Ikes at Cambria
8001 28th Avenue South
PL201900209

CAMBRIA RESTAURANT

TITLE SHEET

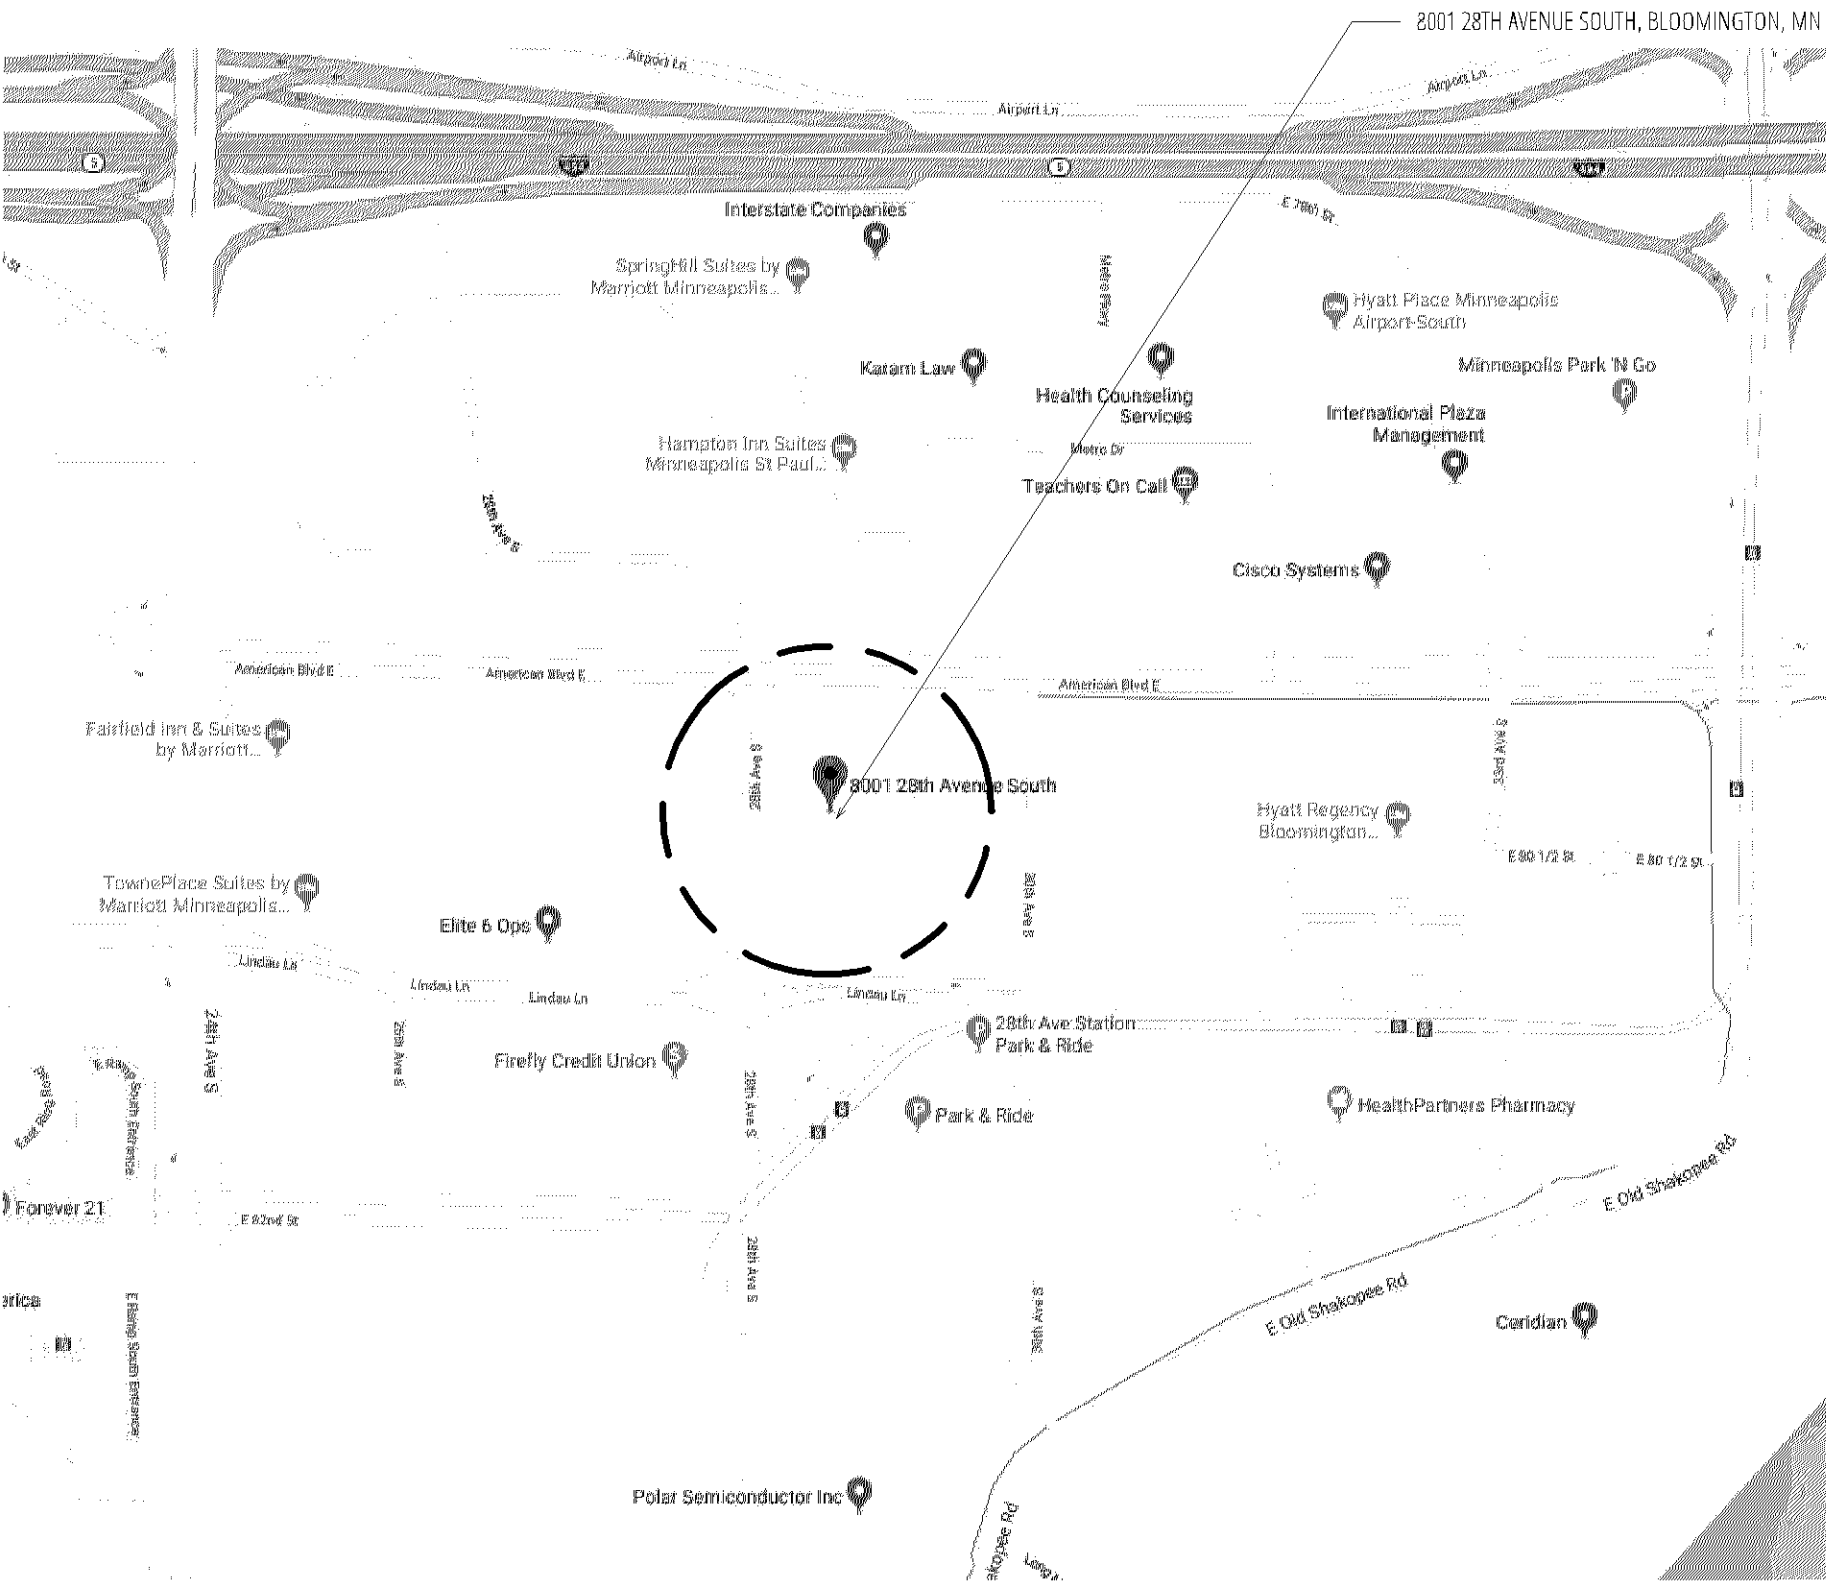
Provide building elevations that identify proposed exterior building materials. EIFS is not a permitted primary material. A minimum 50 percent transparency between 2 and 10 feet is required along 28th Avenue S. and and 25 percent along American Blvd. Include transparency percentages on building elevation drawings.

Provide an overall FAR calculation for the entire development. The minimum FAR in the LX district is 0.7. When the hotel development was approved, the City Council approved a small FAR deviation to go below 0.7. A further reduction approval may be necessary.

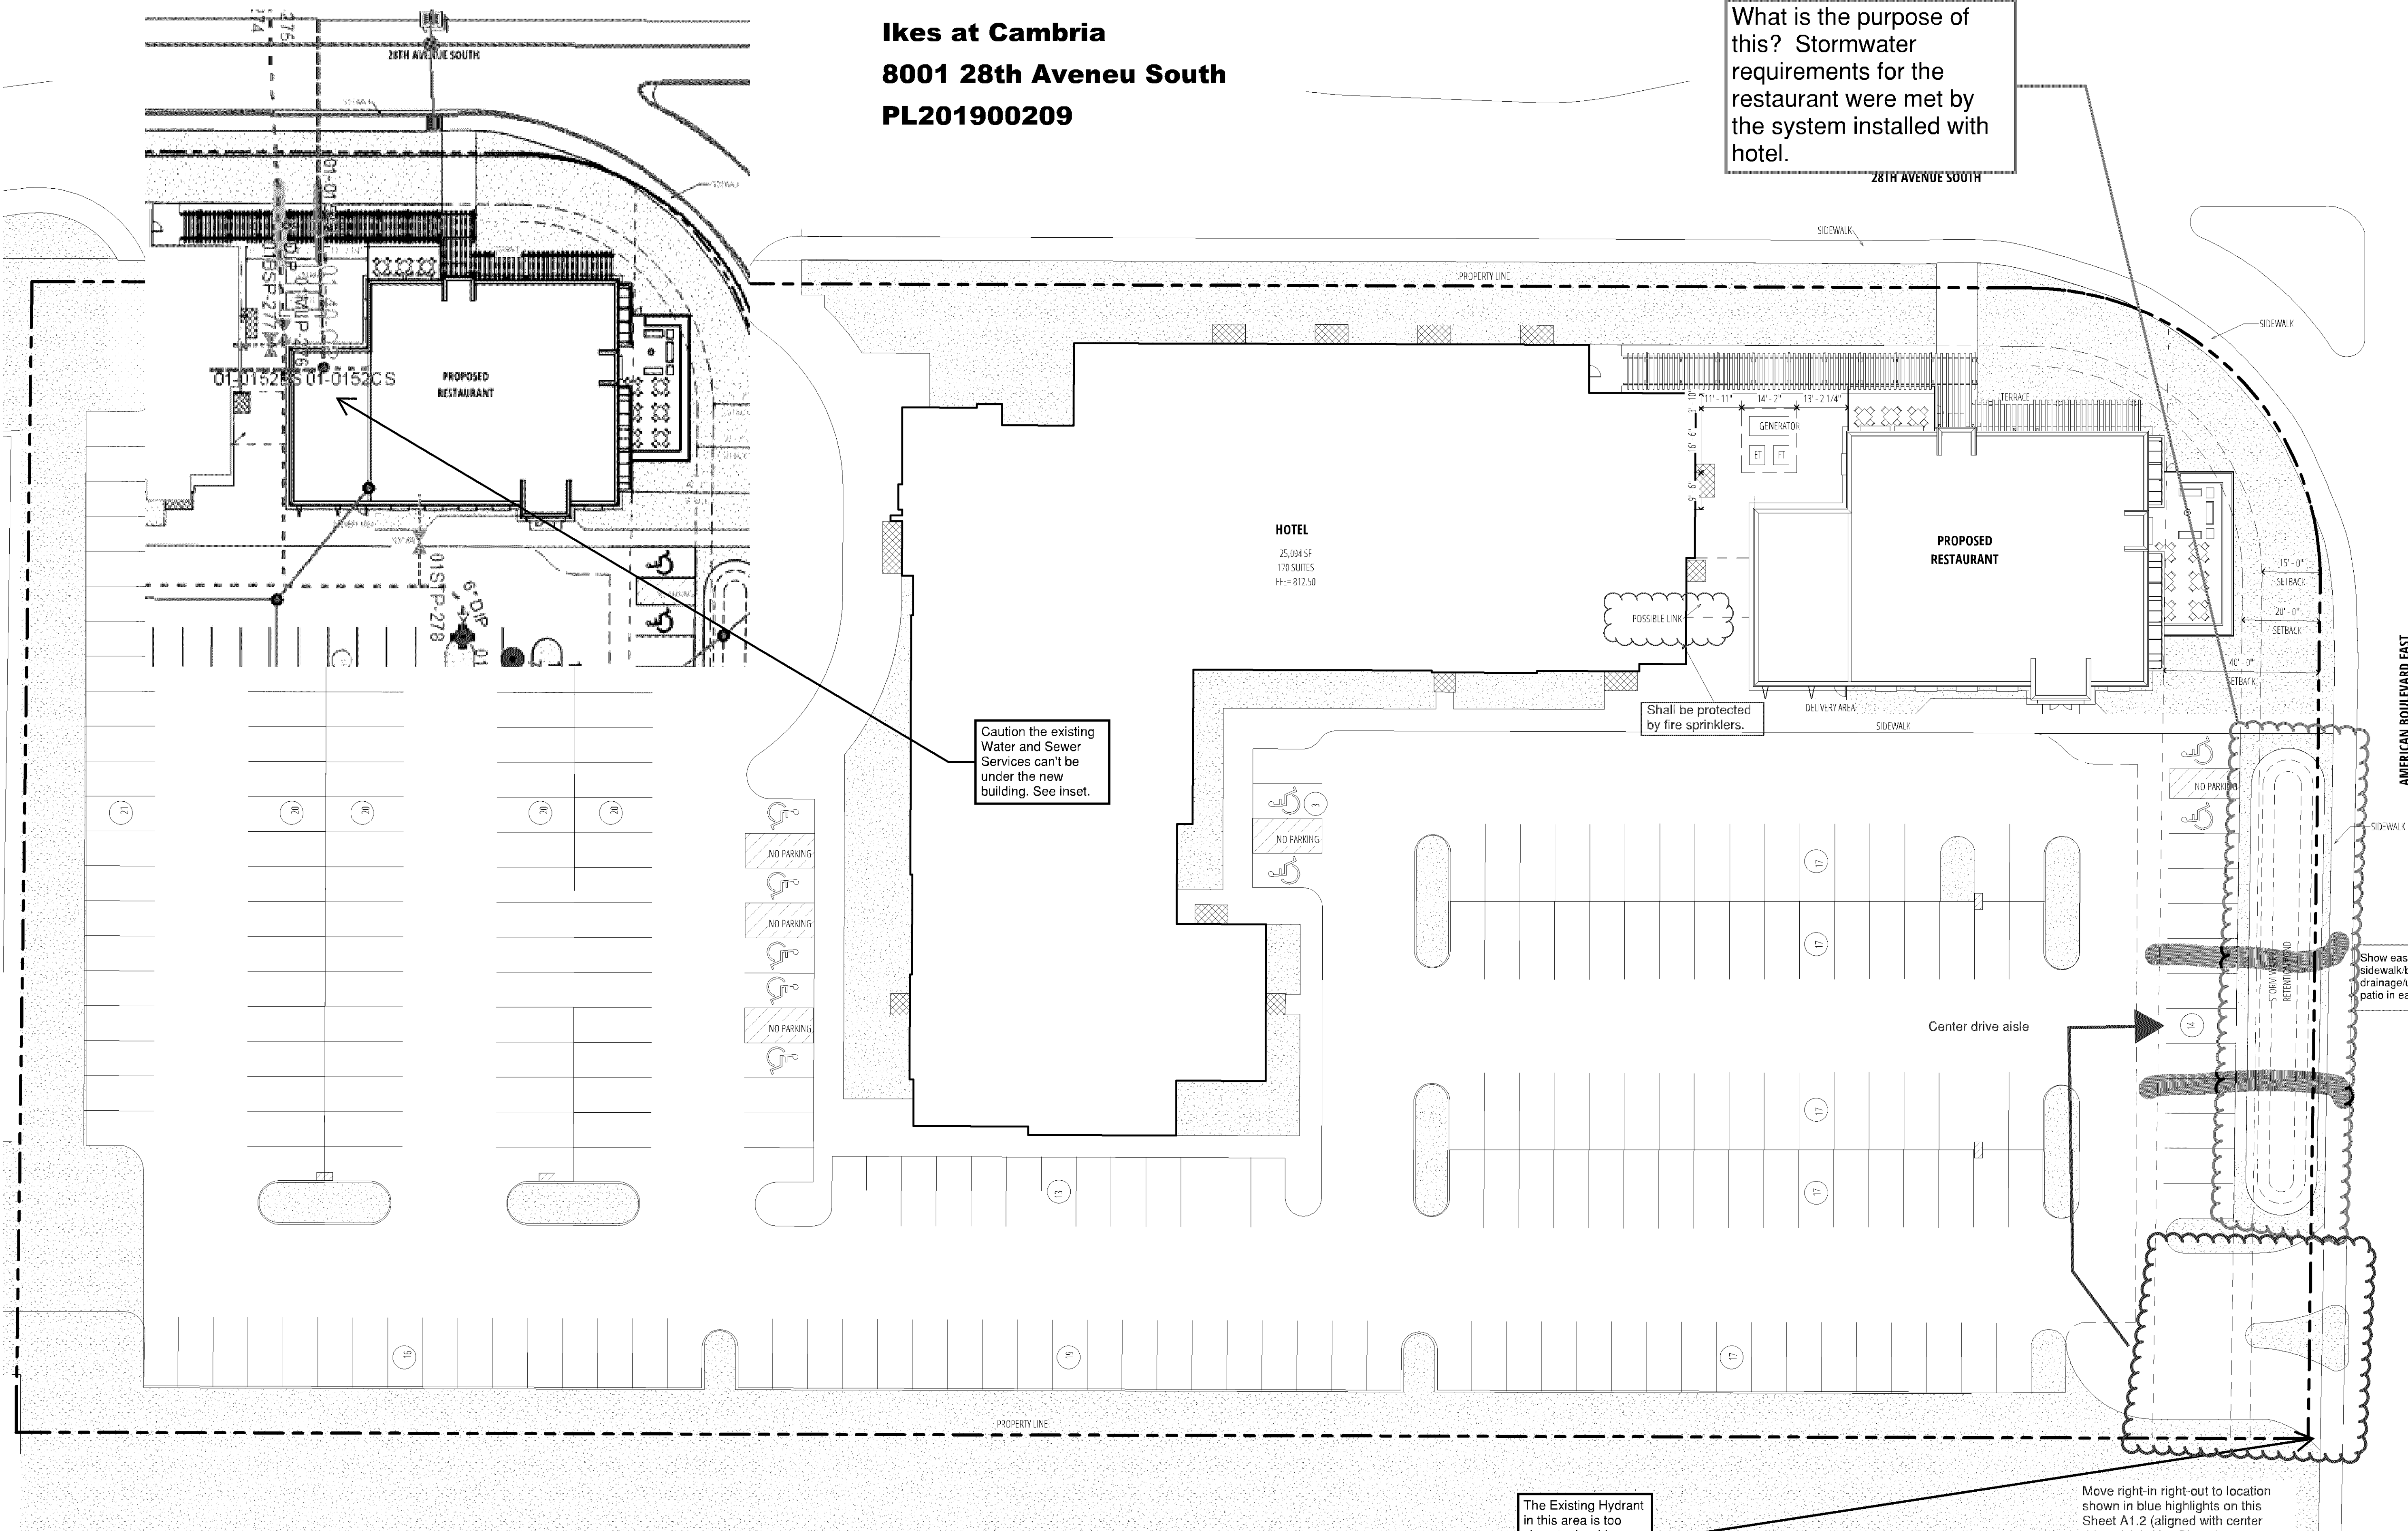
The Cambria Suites preliminary development plan included fully enclosed corridor between the hotel and restaurant. Consider retaining the shared corridor for the proposed restaurant.

Hydrant coverage shall be provided within 50' of the FDC and within 150' of all portions of the structure.

Fire alarm and annunciator panels and Knox box locations to be determined by the Fire Prevention Division.

Emergency responder radio coverage meeting the requirements of appendix L in the 2015 MSFC shall be provided throughout the property and within the structures.

Insure kitchen hood suppression system is an approved UL300 listed system connected to the building's fire sprinkler system.

Fire Department Connection Shall Be front (main entrance) side of building.

insure the proposed landscaping doesn't interfere with access to the building.

Show easements: sidewalk/bikeway and drainage/utility. No pond or patio in easement area.

Correct demolished parking island line work.

13 stalls are depicted along American Blvd. The plan label is 14.

Proposed location of right-in right-out driveway aligns ingress and egress traffic nearly head on, depicts radius extending onto adjacent parcel, and also does not position egress traffic well for accessing the eastbound left turn bay to facilitate an EB to WB u-turn movement (pink highlight).

Radius on adjacent parcel.

Radius on adjacent parcel.

Move right-in right-out to location shown in blue highlights which will facilitate access into the start of the EB left turn bay. Use Bloomington standard commercial driveway

Move right-in right-out to location shown in blue highlights which will facilitate access into the start of the EB left turn bay. Use Bloomington standard commercial driveway detail and no splitter island.

SHEET NO:
A1.2
ENLARGED SITE PLAN

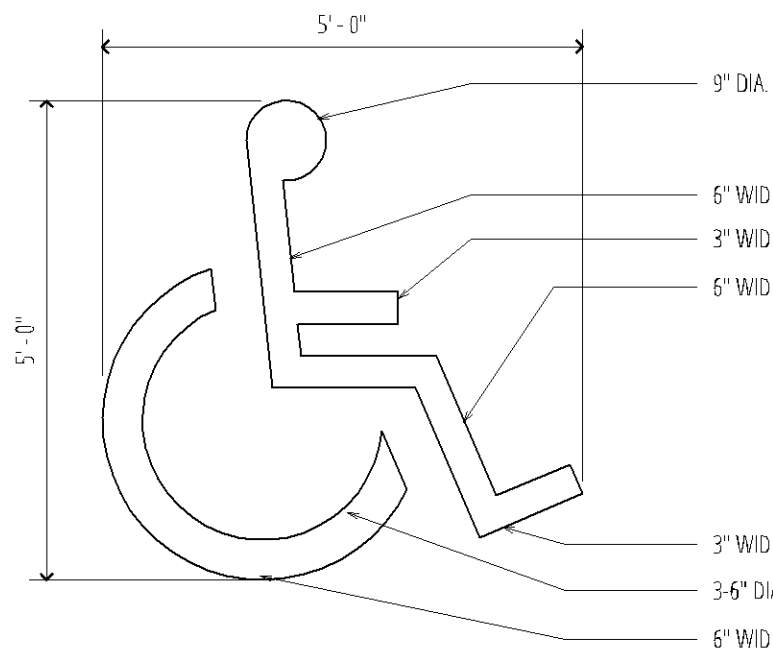
What is the purpose of this? Stormwater requirements for the restaurant were met by the system installed with hotel.

Caution the existing Water and Sewer Services can't be under the new building. See inset.

Shall be protected by fire sprinklers.

The Existing Hydrant in this area is too close to the driveway and may be easily damaged.

Show easements: sidewalk/bikeway and drainage/utility. No pond or patio in easement area.

Move right-in right-out to location shown in blue highlights on this Sheet A1.2 (aligned with center drive aisle). Use Bloomington standard commercial driveway detail, no splitter island.

4
A1.3 CONCRETE CURB DETAIL
SCALE: 1 1/2" = 1'-0"

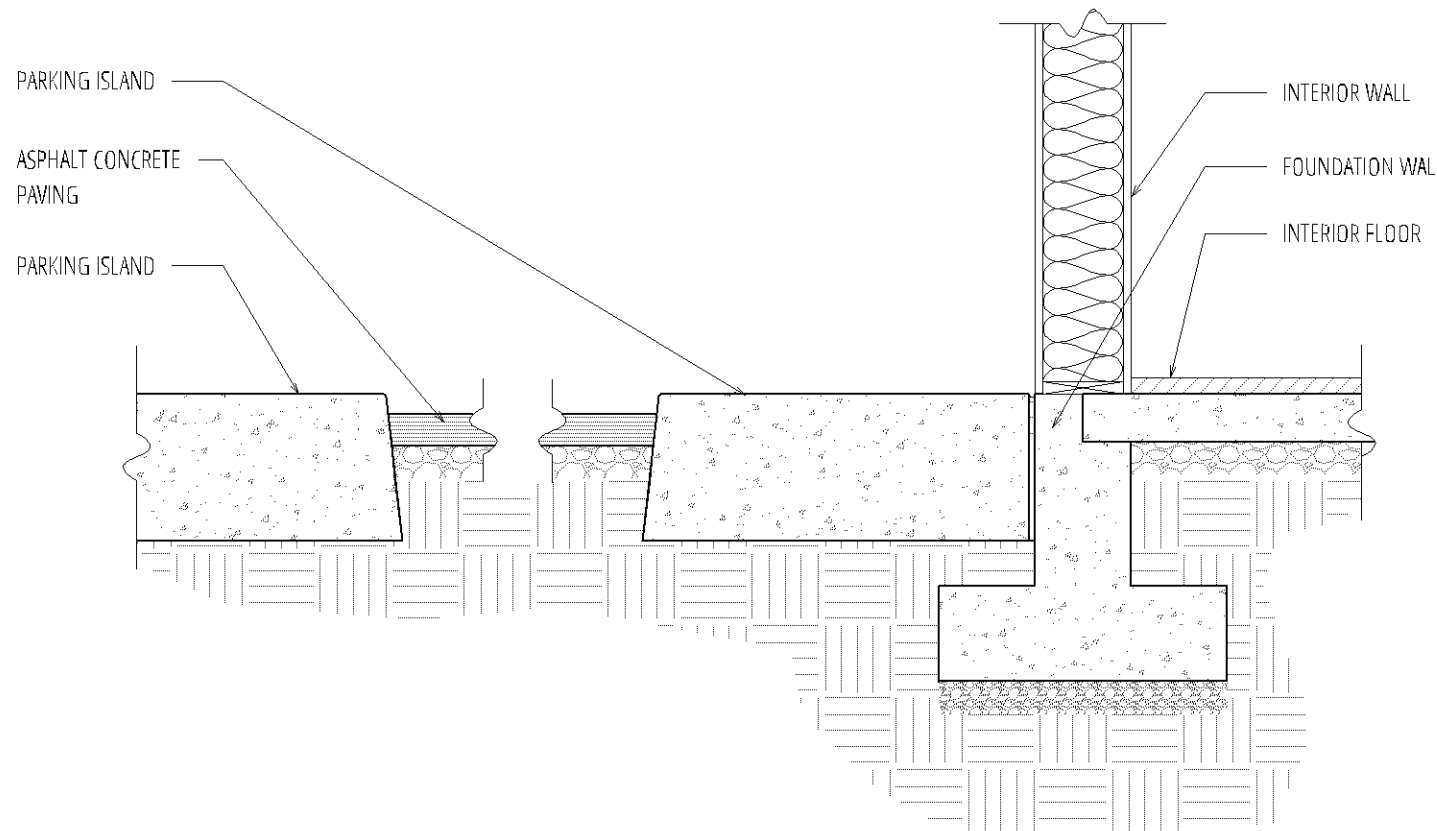
Depth is not show for curb detail
